COUNCIL ASSESSMENT REPORT

Panel Reference	PPSSSH – 143 1 -5 Stanley Street and 1 – 11 Princes Highway Kogarah
DA Number	DA2023/0222
LGA	Georges River Council
Proposed Development	Demolition of existing structures, lot consolidation and construction of a 10-storey shop top housing and residential flat building development containing 102 residential apartments, 3 x commercial tenancies, one office above two (2) levels of basement containing 53 car parking spaces, tree removal, landscaping and site works
Street Address	1 -5 Stanley Street and 1 – 11 Princes Highway Kogarah
Applicant/Owner	Applicant – Mr Aaron Sutherland Owner – Kogarah Investments No.3 Pty Ltd
Date of DA lodgement	13 July 2023
Total number of Submissions Number of Unique Objections	28 Unique Submissions
Recommendation	Refusal
Regional Development Criteria (Schedule 6 of the SEPP (Planning Systems) 2021	Schedule 6 – 2 - General development over \$30 million Development that has an estimated development cost of more than \$30 million. The development has a development cost of \$34,864,225.00

Report prepared by	Brendan Leo – Consultant Planner
Report date	19 May 2024
Summary of s4.15 matters	Yes

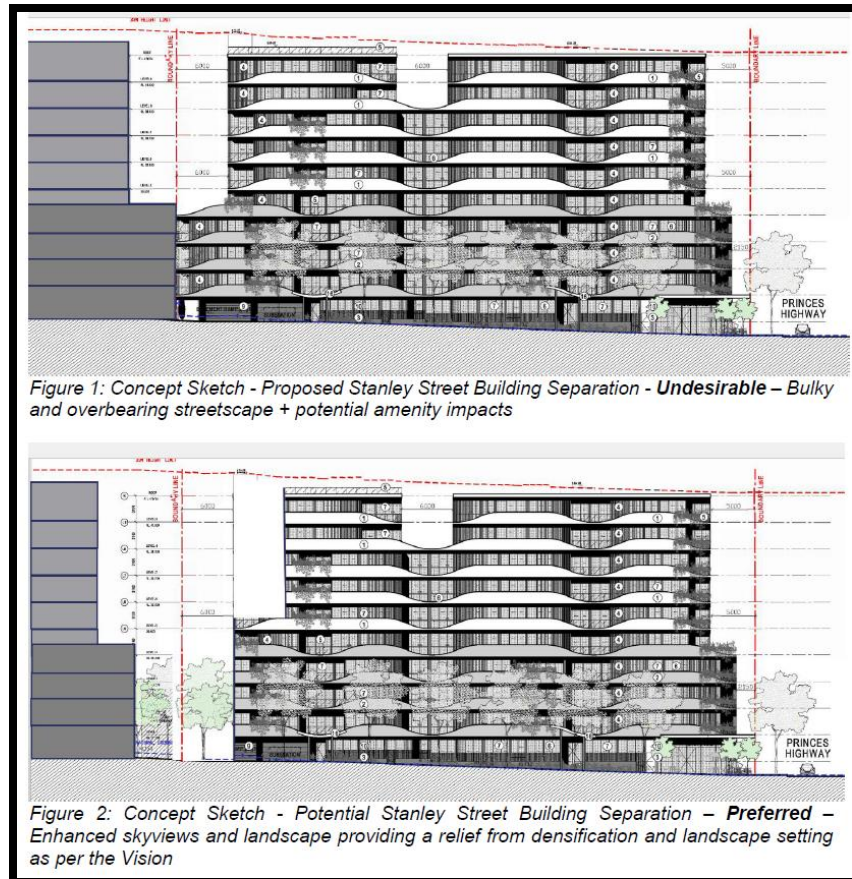
While, the ADG has established that building separation not only ensures that amenity between buildings is maintained but also contributes to the urban form of an area. Hence, one of the aims of building separation under Part 2F of the ADG is to:

It should be noted that the subject site lies within the R4 – High Density Residential area and a continuous podium is not desired. Continuous podium is only appropriate in the business/commercial zones. The lack of setback to the west denies the opportunity for deep soil planting and landscaping to realise the vision. The proposal and any future development to the west will result in overbearing streetscape devoid of landscaping to minimise the impact of building bulk (Refer Figures 1 and 2).

Figure 20: Indicative massing model for 7- 9A Stanley Street Kogarah showing a zero setback to the eastern side boundary for the first 4 levels.

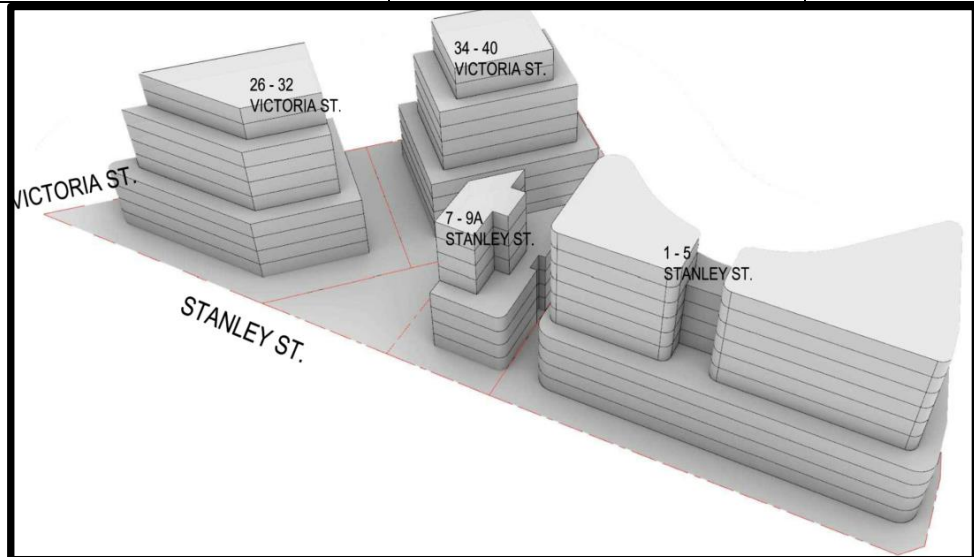
<p>2. Development is not to result in the creation of an isolated site that could not be developed in compliance with the relevant planning controls, including the Georges River LEP 2021, SEPP 65 and the ADG.</p>	<p>The proposal will lead to multiple sites being isolated, the proponents of the development have made attempts in the past to acquire these sites on Stanley Street, however the owner at number 7 Stanley Street was unwilling to sell.</p> <p>The SEE documents the proponents attempts to acquire the adjoining property and also includes concept plans indicating a residential apartment building may be possible on the isolated allotments in Stanley Street. In order for this development to proceed there would need to be multiple variations granted at the DA stage to the relevant planning provisions and any building will likely have compromised amenity outcomes for future</p>	<p>No</p>

occupants. So, the isolation of these sites is undesirable as the streetscape will be compromised as the envisaged development form will not be able to be realised.	
--	--	--

4. If an application proposes a redevelopment that does not comply with the amalgamation pattern identified in Table 1 above, or where the proposal would result in an isolated site with a minimum site frontage of less than 60m, the applicant must submit to Council with the Development Application justification to vary the amalgamation pattern requirements.	There are no amalgamation pattern requirements.	N/A
	The isolated sites will have a frontage to Stanley Street of approximately 18m and a total land area of approximately 633sqm, whilst indicative floor plans and a massing model has been presented by the applicant to justify the viability of the redevelopment of the isolated sites. The plans presented rely upon multiple variations to planning controls and at this time it is uncertain given the small size of the remaining holdings if the sites can be redeveloped successfully.	No
